Clairemont Mesa

Community Plan

Proposed Community Plan Amendment for the
Balboa Avenue Station Area Specific

2005 Street Classifications and Recommendations
Clairemont Mesa Community Plan

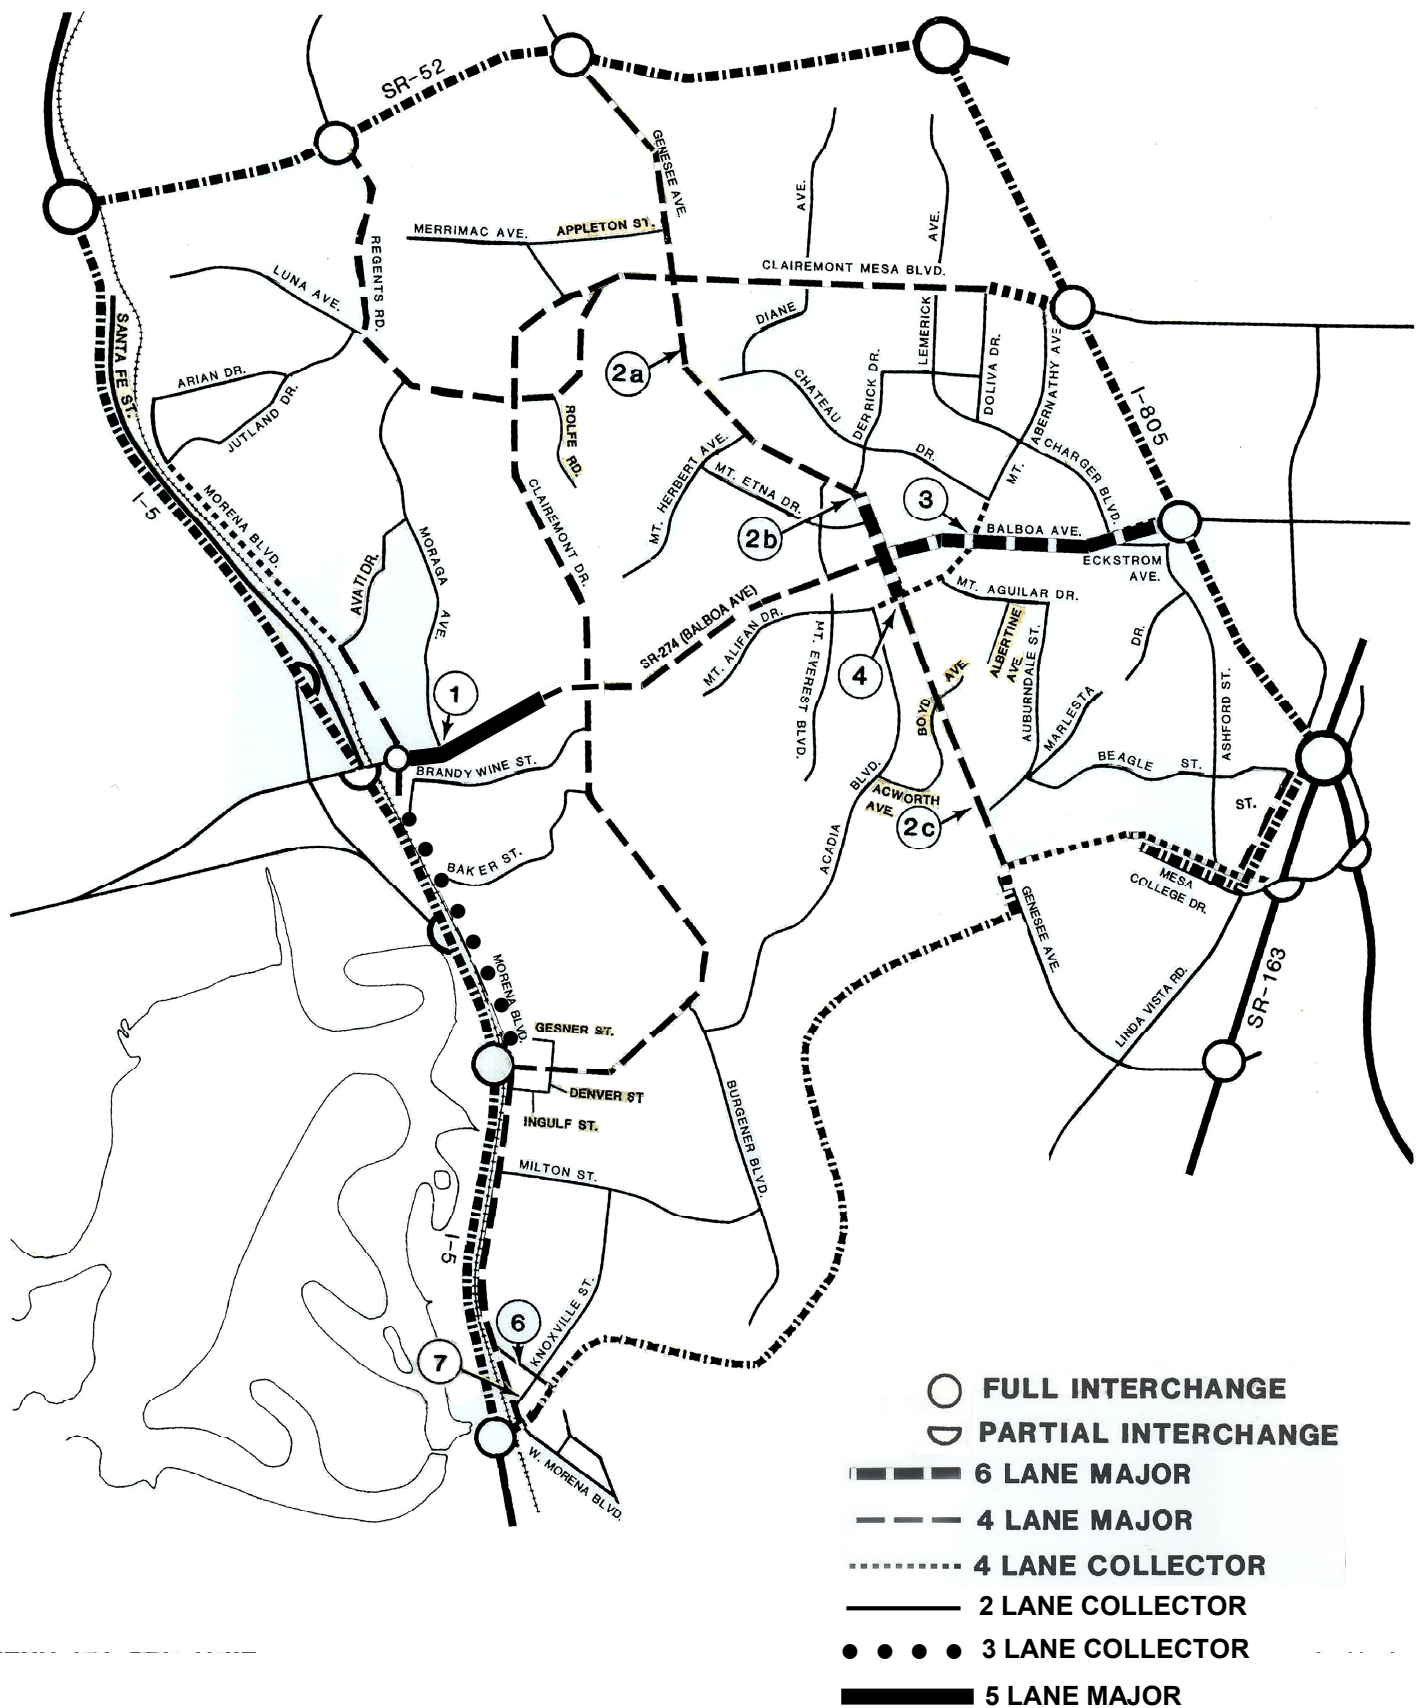
A series of street improvements should take place in Clairemont Mesa to accommodate the increase in traffic volumes projected for the year 2005 (**Figures 22 and 23**). (The recommendation numbers below correspond to numbers on **Figure 22**.)

Balboa Avenue should be ~~widened-maintained from as~~ a four-lane major ~~to a six-lane major~~ from Clairemont Drive to Moraga Avenue and maintained as a five-lane major from Moraga Avenue to the community's western boundary at I-5. ~~The six-lane major should continue just east of the intersection at Clairemont Drive to provide a transition to the four-lane major.~~

Recommended Bikeway System

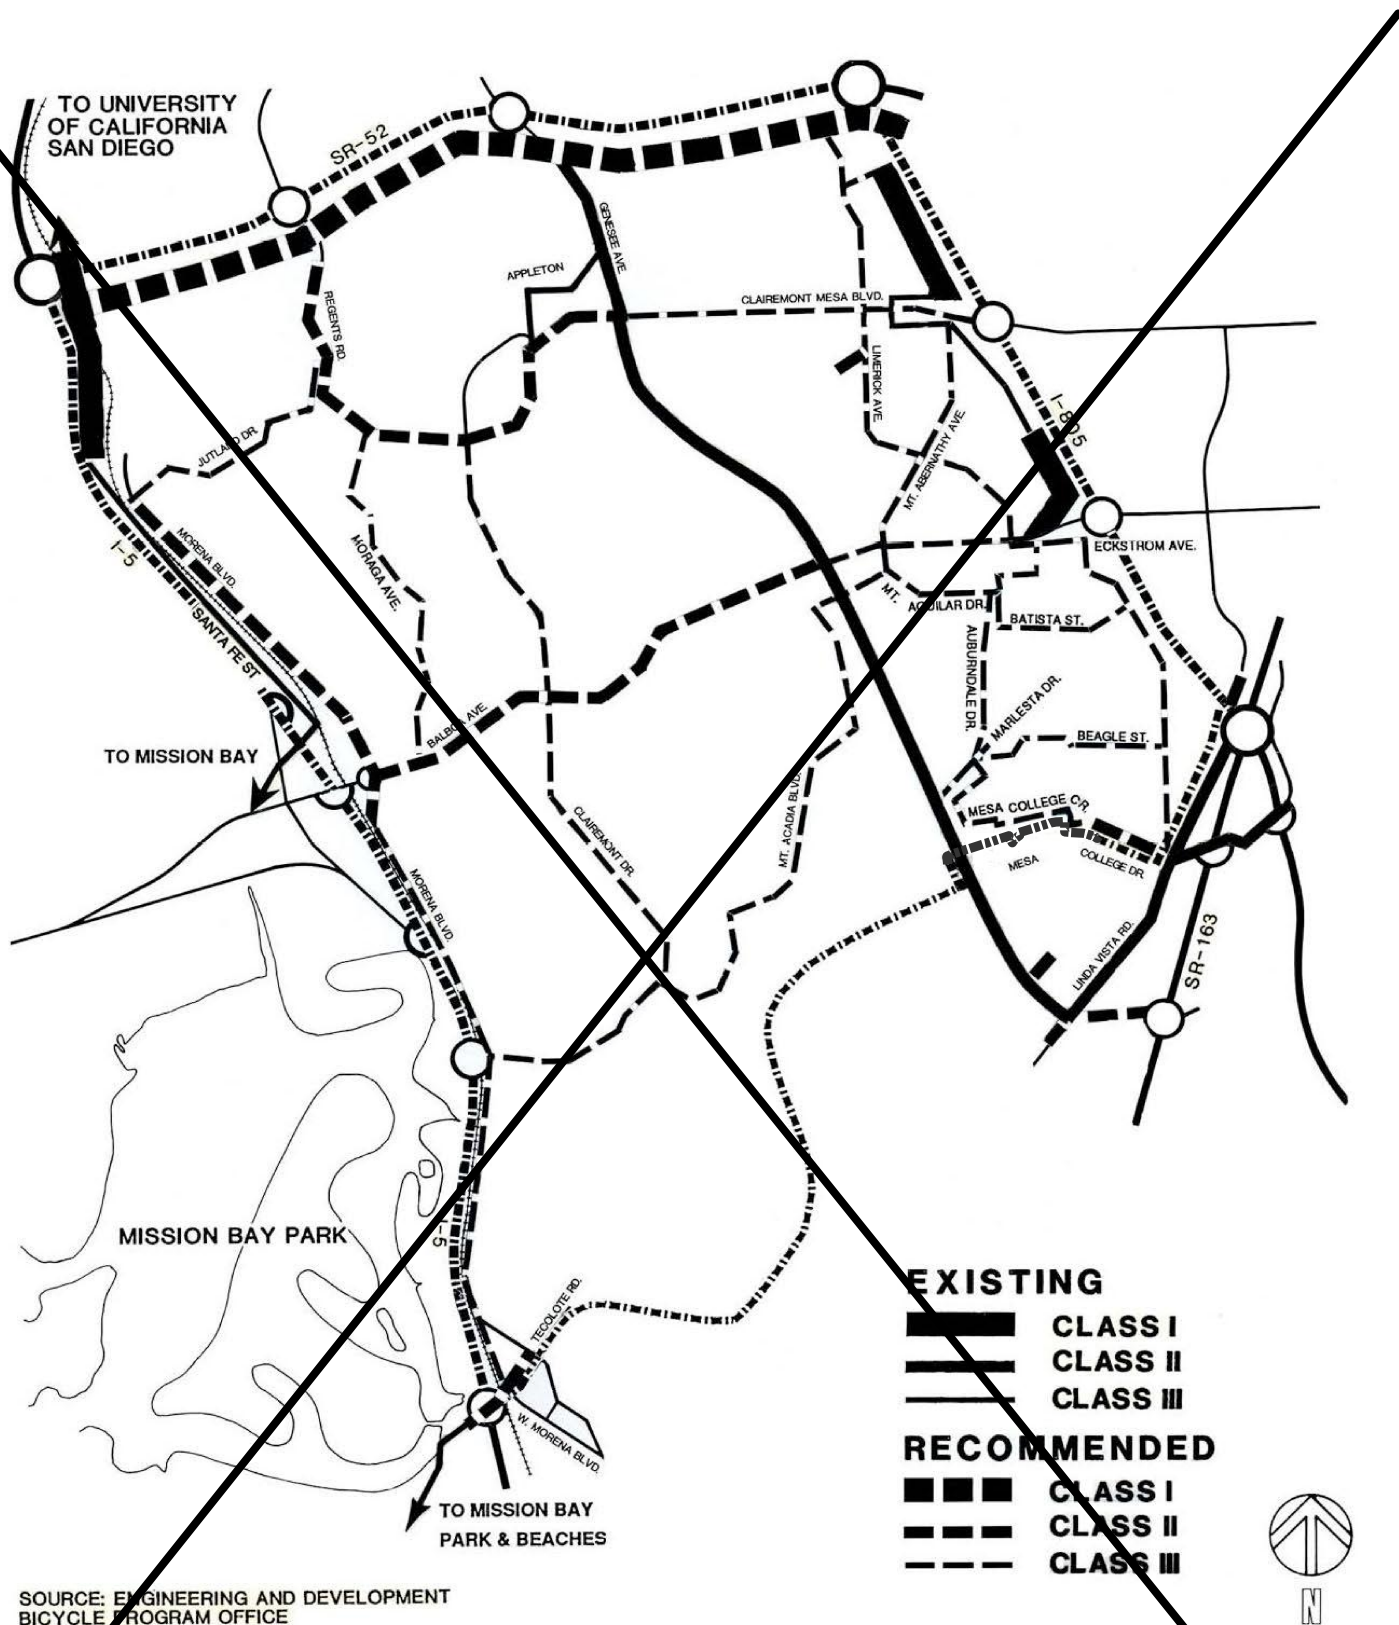
**CLASS I**
 **CLASS II**
 **CLASS III**
 **CLASS IV***

*For additional information related to the Class IV bicycle facility identified for Morena Boulevard, see the Balboa Avenue Station Area Specific Plan.
